**PLANNING COMMISSION
THURSDAY, JUNE 3, 2021 6:00 PM**

1. Application #2021-5215; National Road SW; Applicant Joe Ciminello; Major Site Plan (Eastwood)
2. Application #2021-5214; National Road SW; Applicant Joe Ciminello; Preliminary Plat (Eastwood)
3. Application #2021-5083; 1122 & 1170 Lancaster Avenue; Applicant Laurie Gunzelman; Amendment of Development Plan (The Oliver)

RE: East Main – Major Site Plan #2021-5215 Staff Report

On behalf of the City of Reynoldsburg, EMH&T conducted a preliminary engineering review of the private development plan for the Eastwood project. The following summarizes our findings and recommendations with respect to this development.

SITE PLAN

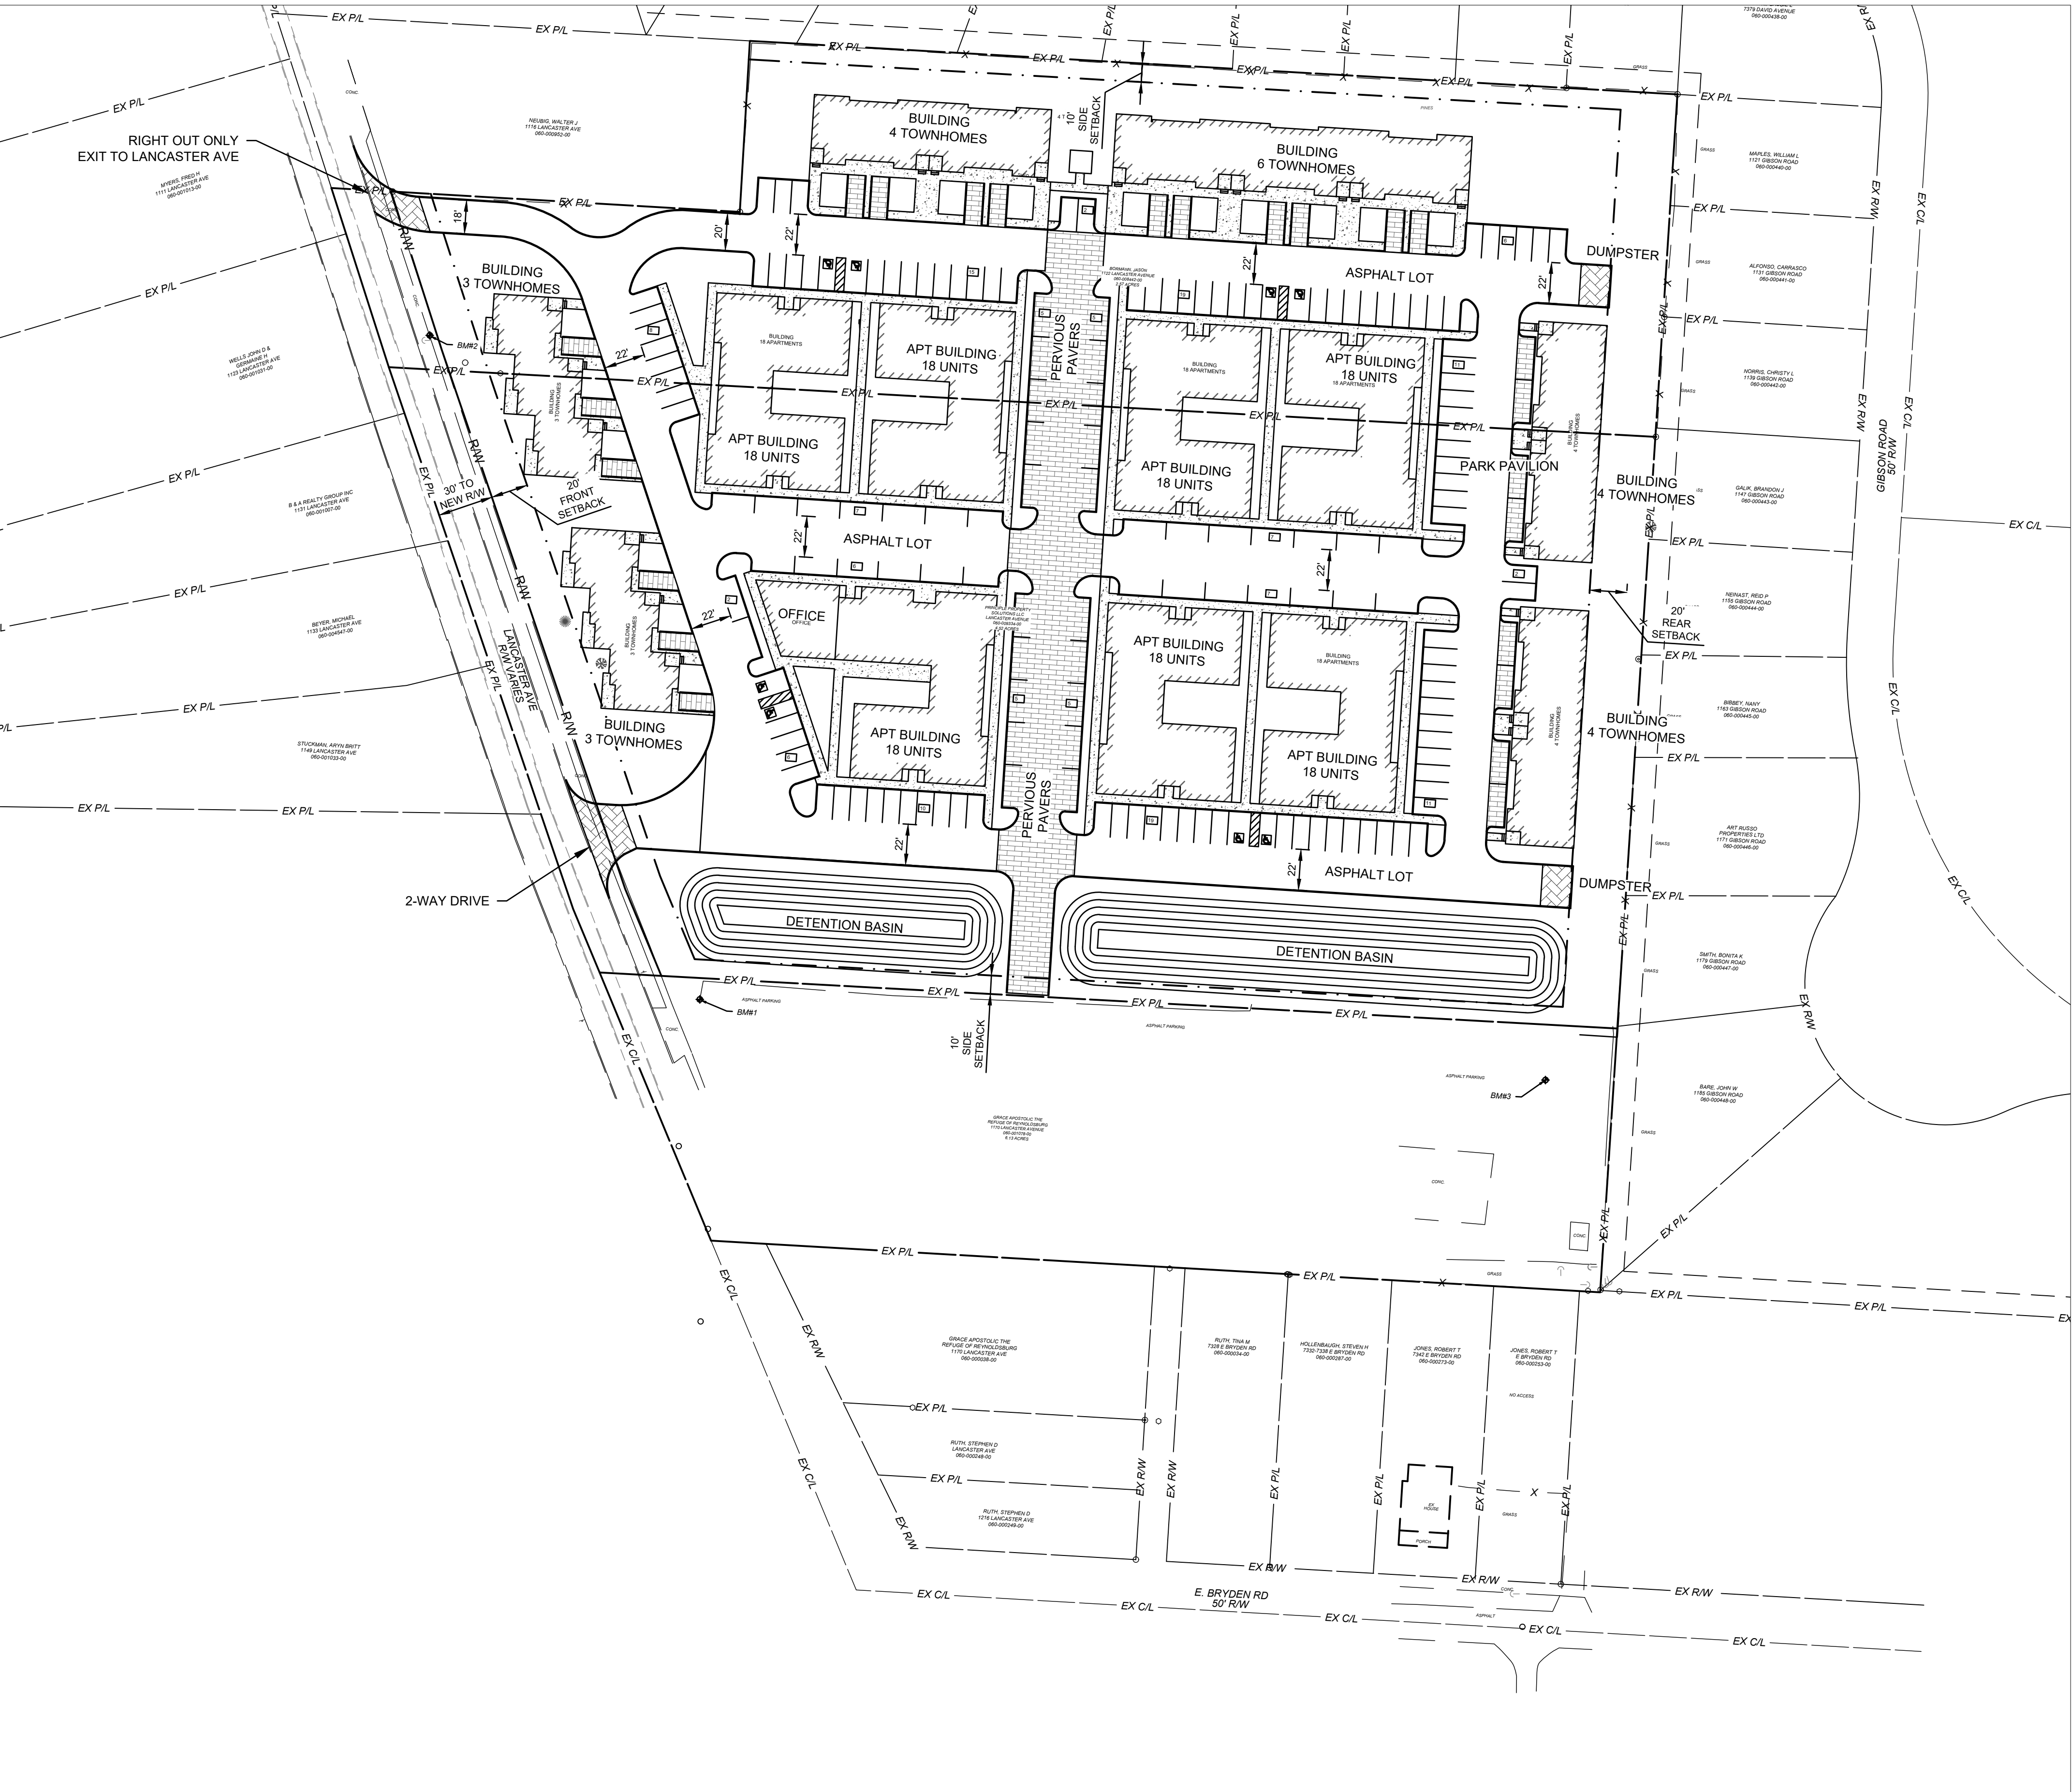
2. The site plan includes two access points on the east side of Lancaster Avenue; one at the northwest limits of the development and one to the southwest. The northwest access point is currently shown as a right-out-only access. The southwest access is two-way. There is an additional access point along the southern property line that will connect into the existing pavement of the neighboring Grace Apostolic Church. It is assumed that an access easement and/or agreement will be required between the properties.

6. Although a typical section is not provided, it is assumed the section will be an inverted crown with catch basins in the center of the drives, as shown. On the PGU, please provide pavement section and curb details, as well as locations of underdrain, if applicable.

17. Provide flood routing arrows on future submissions.
18. Given the proximity of the basins to proposed drives and the church property to the south, we recommend that a barrier such as fence or guardrail be incorporated to provide protection for vehicular and pedestrians.

19. Please label the structure on between the residential buildings on the north side of the site. Is this a mail building?
20. Please provide an existing conditions plan showing the existing topography, utilities and other features currently on the subject site.
21. The project will require a lot combination as it is currently two separate parcels.
22. Where applicable, refer to Reynoldsburg Standard Construction Drawings.

UTILITY PLAN

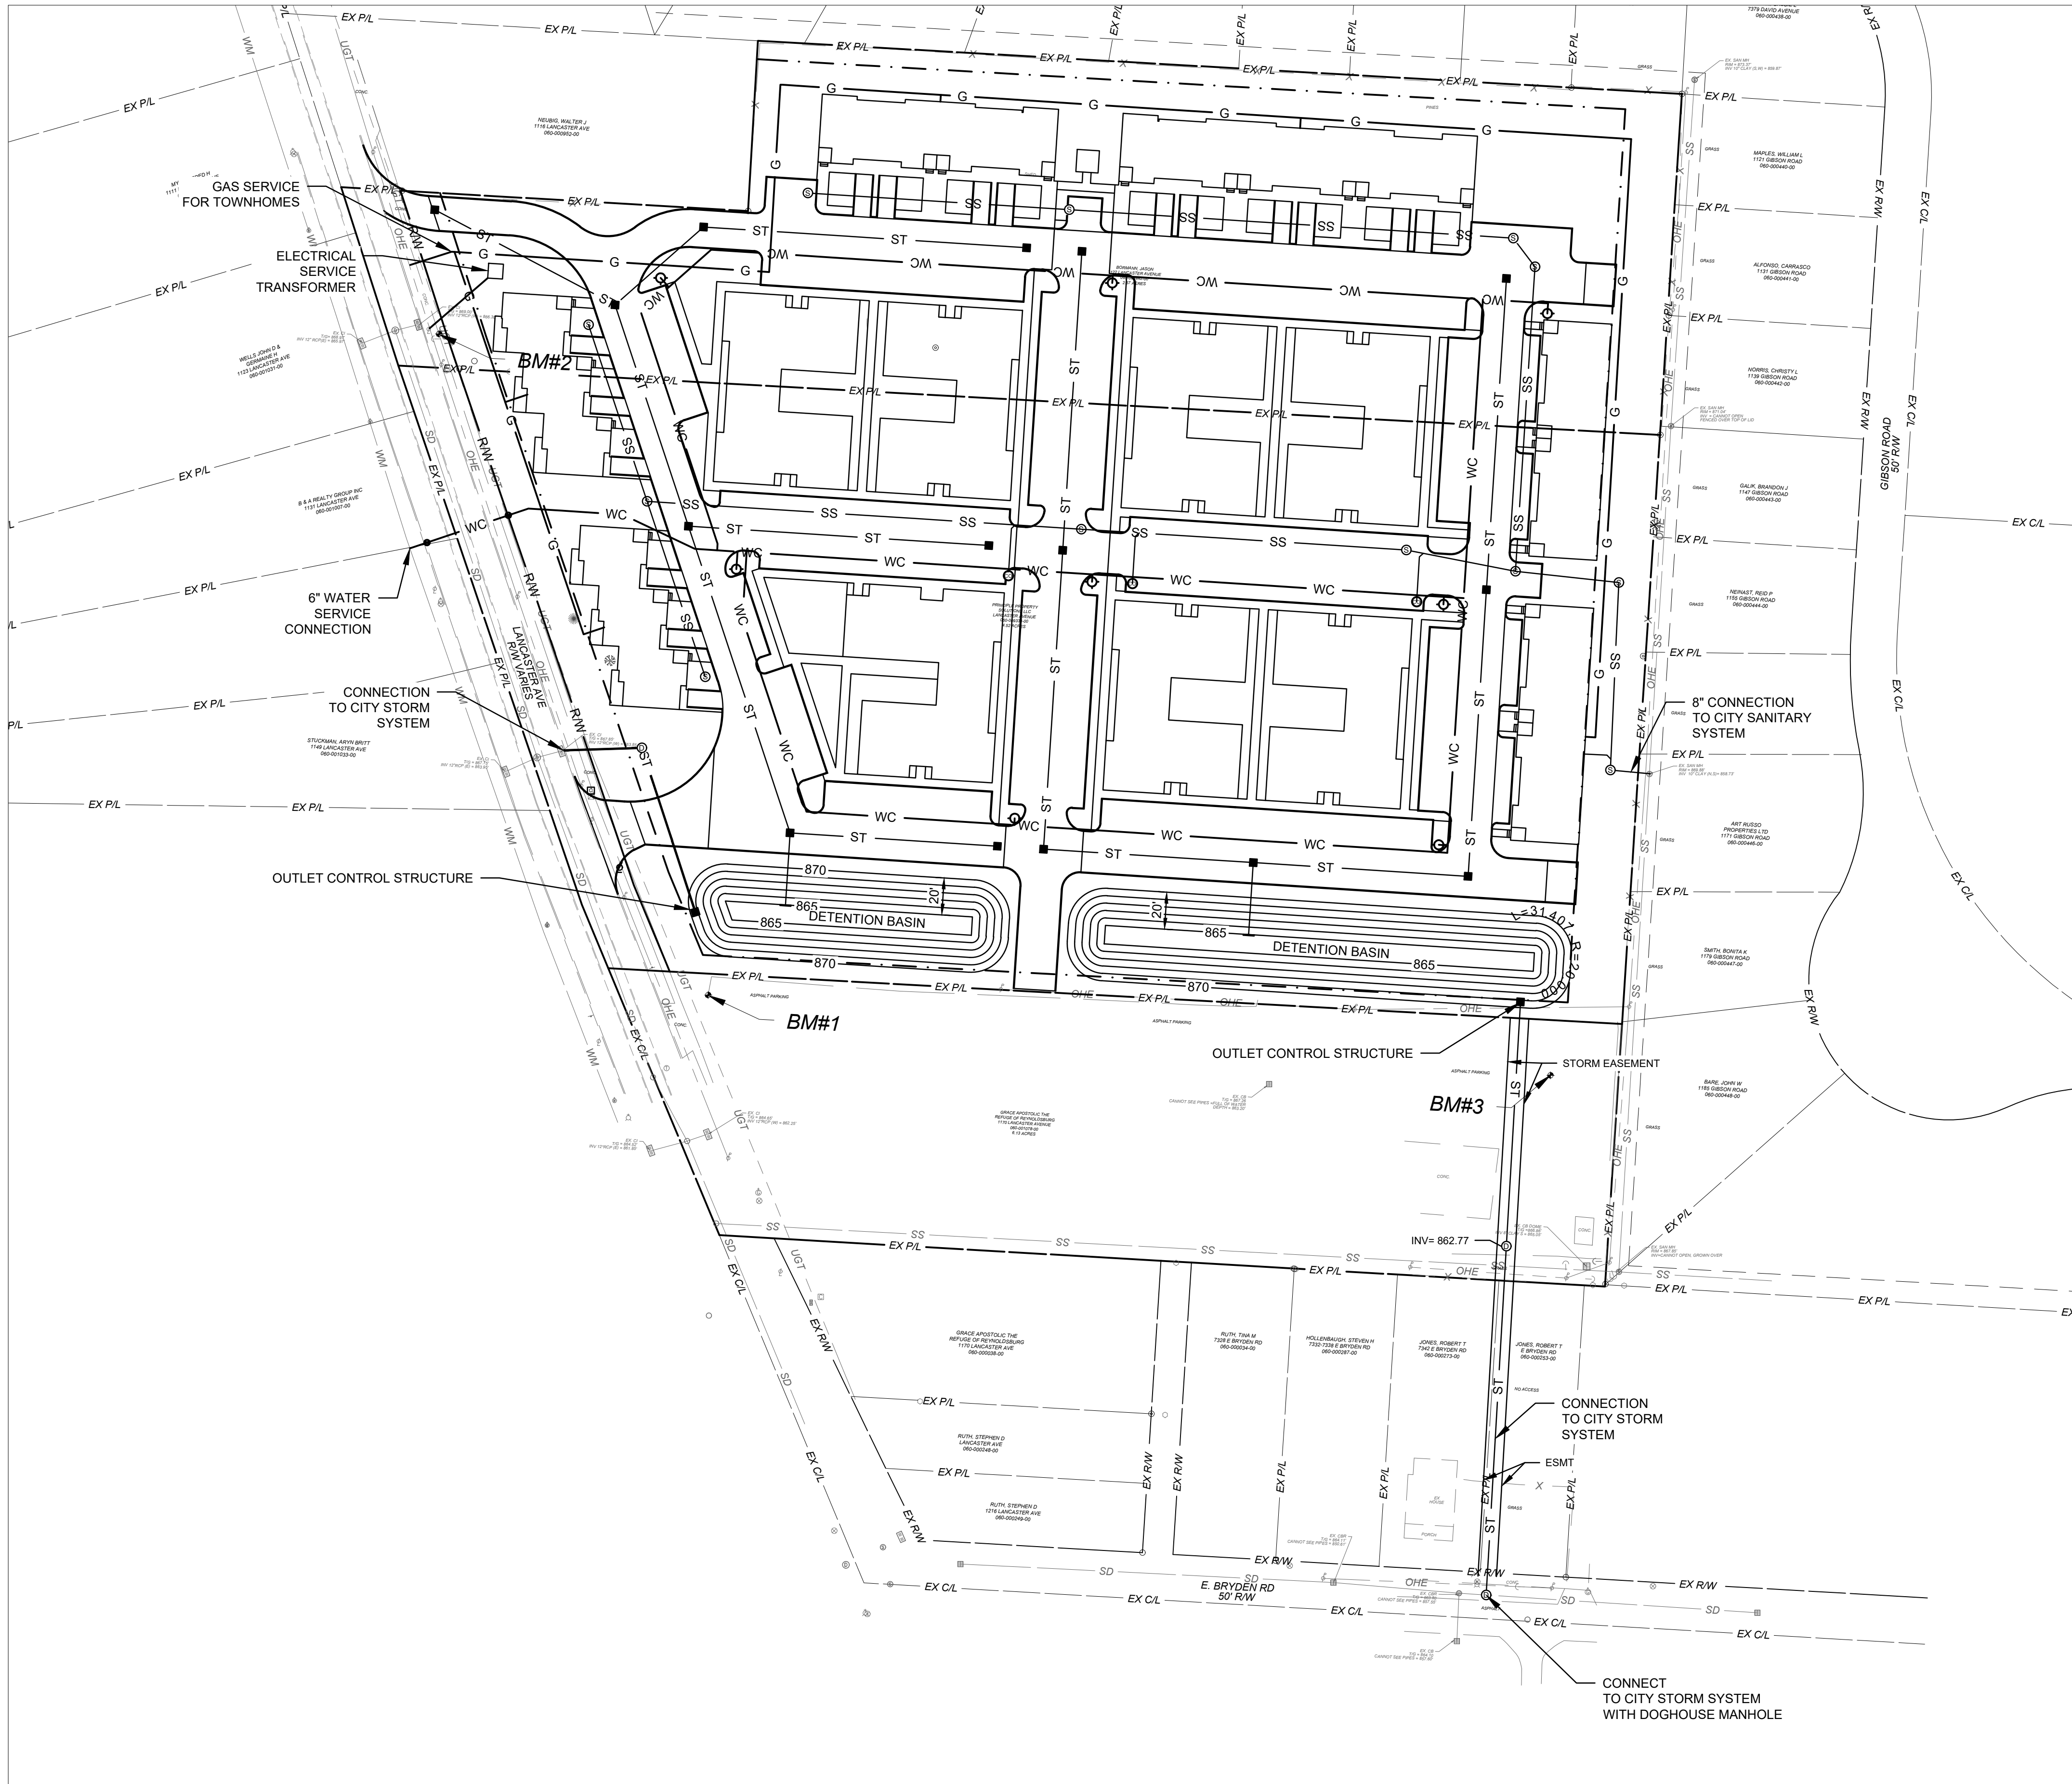
8. Provide Water and Sewer demands through the Facility Demand Worksheet.
9. The plans show a 6" private water connection from the existing watermain on the west side of Lancaster Avenue. Provide calculations that show a 6" tap and private watermain can support not

10. Show water meter pit and hot box(es) in PGU.
11. The site's sanitary sewer system will connect to an existing 12" sanitary sewer along the eastern property line of the project. Minimum 20' easements must be provided for the sewer within the project and must be shown and labeled on the plan. If the project is not being platted, the easement legal descriptions and exhibits must be submitted with the PGU.

12. Submit sanitary calculations and tributary map with the PGU. Please show within the calculations that the existing sewer immediately downstream of the connection point (from connection manhole to next downstream manhole) has available capacity for the project.

15. The western detention basin is shown outletting into an existing curb and gutter inlet on the west side of Lancaster Avenue which has a 12" outlet pipe. As part of the stormwater management report, provide evidence that the existing 12" pipe has capacity to accept the flow from this basin.

16. The eastern basin is shown outletting to the south through the Grace Apostolic Church and Robert Jones properties and connecting to an existing 12" storm sewer in Bryden Road. Easements will be required through these properties and have been shown. Please provide the City with evidence that these owners are acceptable to these easements. Additionally, demonstrate that the existing 12" sewer has capacity to accept this flow in the stormwater management report.
